# **TORONTO** STAFF REPORT

Subject: Final Report  
Rezoning Application 05 202688 NNY 23 OZ  
Applicant: Sungho Kim, Twins Peak Construction Ltd.  
Architect: Don Bielech, Don Bielech Architect  
210 & 212 Finch Ave W  
Ward 23 - Willowdale

This report reviews and recommends approval of an application to amend the Zoning By-law for a proposed 8 unit, 3-storey residential townhouse development located at 210 & 212 Finch Avenue West.

# Attachment 1: Site Plan

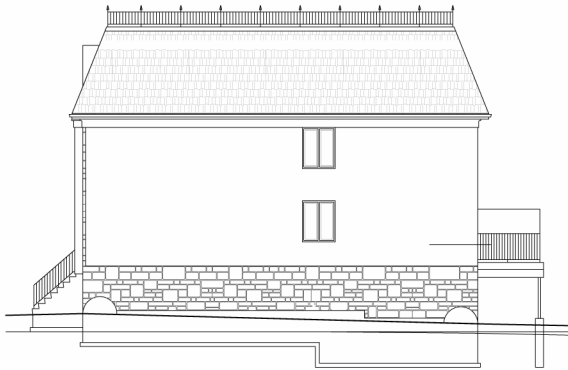
9. The Drawing GO1, Servicing Plan, must be amended to show that each unit of townhouse will have individual water services connected directly to the City's watermain on Finch Avenue West. One common water service is not allowed, however the common sanitary and storm service will be allowed.

11. There is concern as to the maneuverability from the spaces at the east end of the site, adjacent to proposed dwelling unit 8. The provision of a turn around area is required at this location. All turnaround areas must be maintained at a depth of at least 2.7m, so as to enable vehicles to reverse from the spaces and exit in a forward direction. All turnaround areas must be hatched out with painted line markings prohibiting parking in the space. Revised plans and vehicle turning diagrams can be used to detail how vehicles will maneuver into and out of the proposed turnaround areas, and/or a sufficient area for the purposes of vehicle turnaround.

12. The maximum slope down of a driveway shall not exceed 10%, as per By-Law 7625. Current plans A8 detail a slope to the garage, however, a slope is not specified, and associated plans do not detail any further information. Revised plans must detail explicitly whether a slope driveway per dwelling unit is proposed.
